## Product Advisor (PA)

**Subject:** Datasheet Correction for Listed Intersil ISL55012IEZ-T7 and ISL55014IEZ-T7\* Products

**Publication Date:** 7/19/2017

**P6.049A**

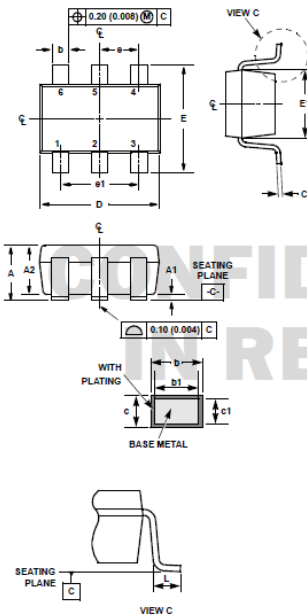
The datasheet for the listed ISL55012\* and ISL55014\* products has been updated to correct the Theta Ja value from 200 °C/W to 255 °C/W and include the correct package outline drawing (POD) as shown in appendix A.

From:

To:

**P6.049B**
